SERVICE BULLETIN No

18-3

PRODUCTION CHANGE

SUBJECT: EXHAUST MANIFOLDS
VEHICLES: 3.2 MONDIAL - 328

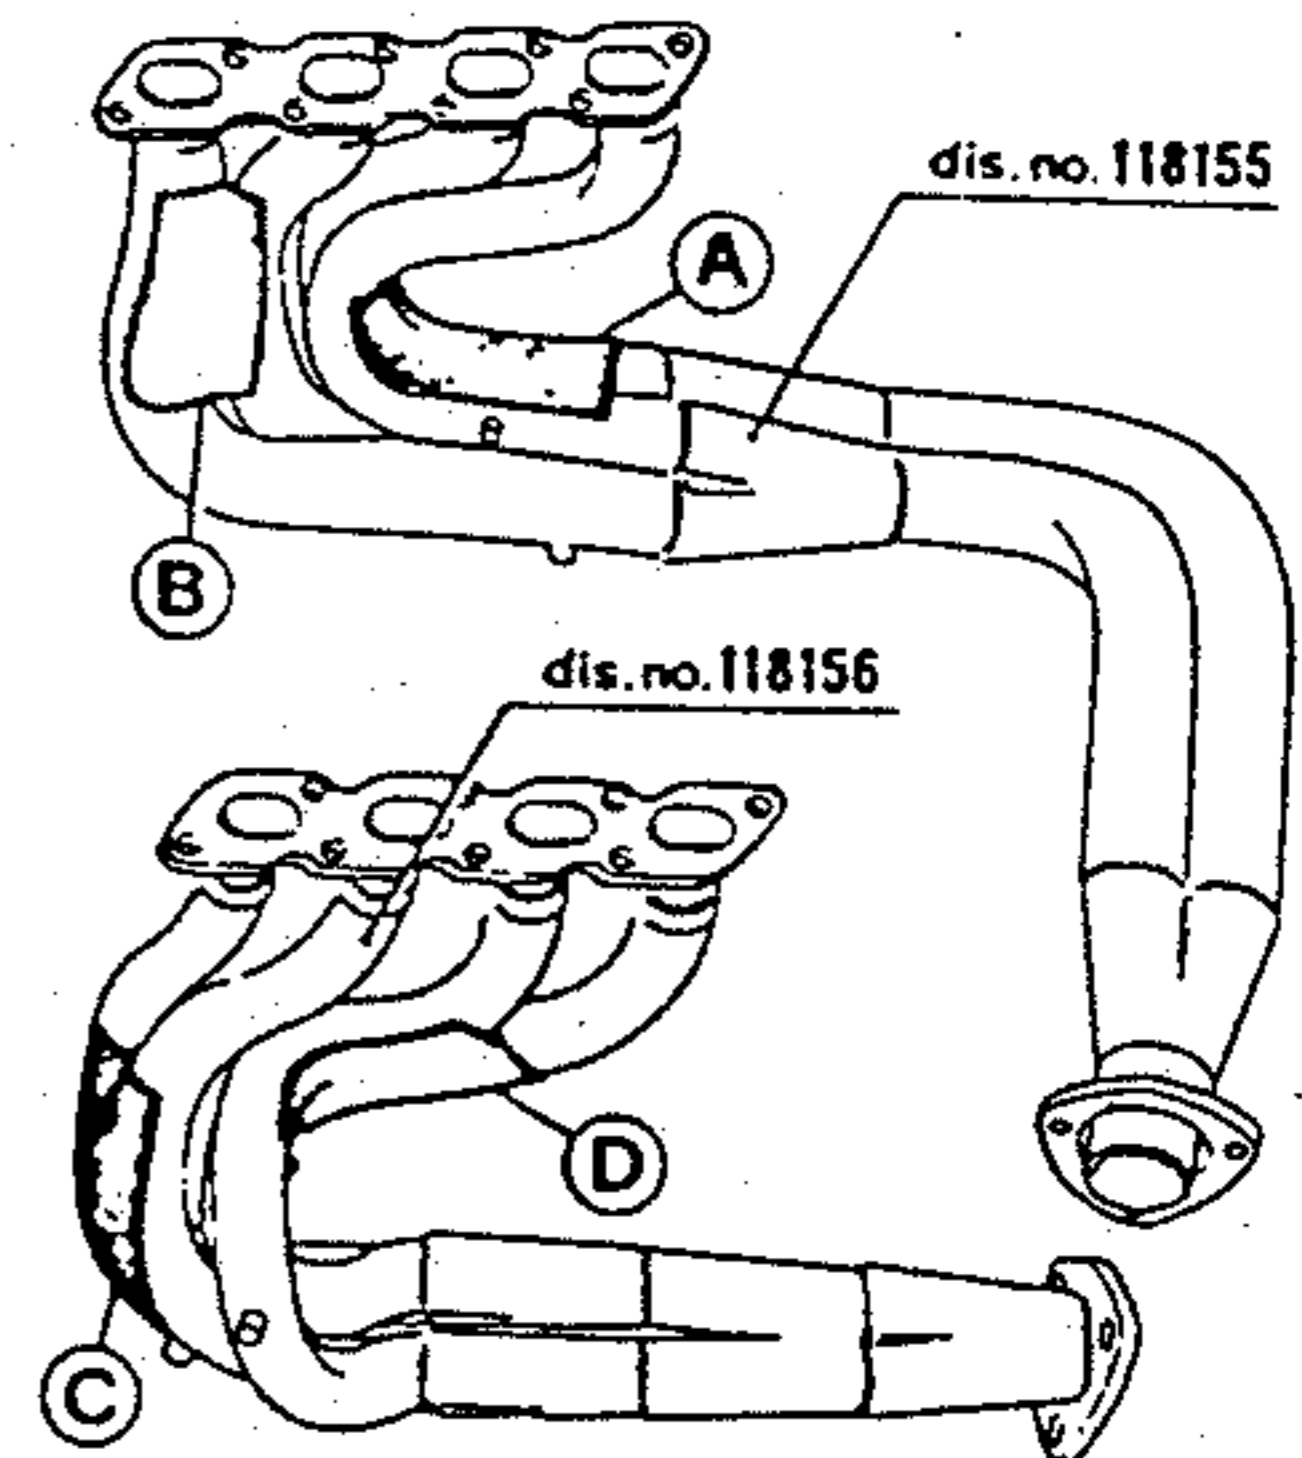
Modified exhaust manifolds, with additional gusset plates (A-B-C-D) are being used. The modified manifolds keep the same part number of the previous one (118155 - 118156).

More efficient dampening of vibrations and noise.

The Ferrari Spare Parts Dept. will supply modified exhaust manifolds only.
